Engineering - Final Plat Checklist

7. C. Final Plat

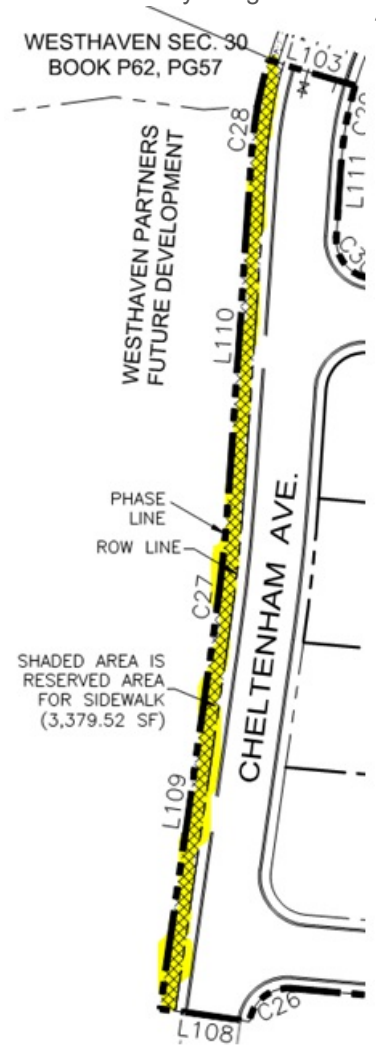
[lance.fittro@franklintn.gov](mailto:lance.fittro@franklintn.gov) Extend the ROW along Cheltenham Ave to include the hatched area currently indicated as "reserved area for sidewalk." The ROW line should coincide with the section boundary along the area highlighted below:

[lance.fittro@franklintn.gov](mailto:lance.fittro@franklintn.gov) The previous comment, "Extend the ROW along Cheltenham Ave to include the hatched area currently indicated as "reserved area for sidewalk." The ROW line should coincide with the section boundary along the area highlighted below." has not been addressed appropriately.

The section boundary shall match that shown on the associated site plan, COF #6747, which generally follows the back of sidewalk along the west side of Cheltenham Ave. The site plan shall match the plat, including the location of the development section boundary.

[jgregg@wilsonpc.com](mailto:jgregg@wilsonpc.com) The section line has been moved to the boundary line. They are now one and the same. The shaded sidewalk area remains but it is outside of the boundary and section line.

### 8. C. Final Plat

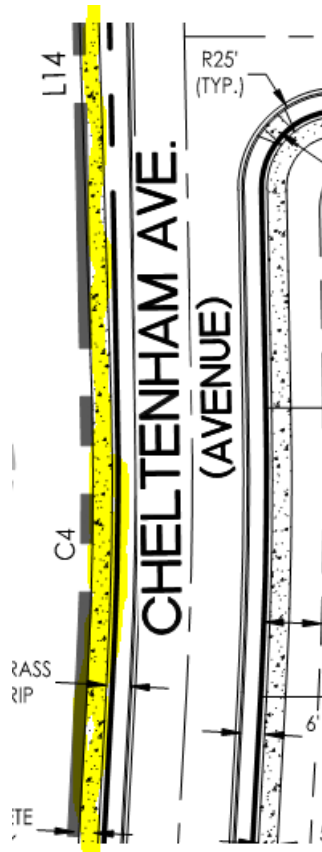
[lance.fittro@franklintn.gov](mailto:lance.fittro@franklintn.gov) To ensure appropriate easements are provided, Applicant shall revise the plat to show proposed public infrastructure matching that shown on the associated Site Plan. Infrastructure may be noted on plat as "*proposed*".

Public infrastructure to be shown on plat includes proposed street improvements, curb and gutter, storm infrastructure, sidewalks, multi-use trails, and extents of proposed public utilities. Proposed private infrastructure is not to be shown on plat.

The sidewalk indicated on the site plan to be constructed within the "reserved area for sidewalk" is to be shown on the plat:

[lance.fittro@franklinton.gov](mailto:lance.fittro@franklinton.gov) The sidewalk shown on the associated site plan to be constructed along the western edge of Cheltenham Avenue shall be shown on the plat. This is public infrastructure shown to be constructed with the site plan and for which sureties are to be posted ensuring its construction.

Any portion of the public sidewalk which falls outside of the ROW shall have a public access easement for the sidewalk shown on the plat.

Shifting the section boundary to show a hatched area for future sidewalk construction on un-platted land without the required access easement does not match the associated site plan, and is not acceptable.

[jgregg@wilsonpc.com](mailto:jgregg@wilsonpc.com) All infrastructure shown on the plat is proposed. The proposed sidewalk area is shown outside the boundary line of section 53 as a reserved area.
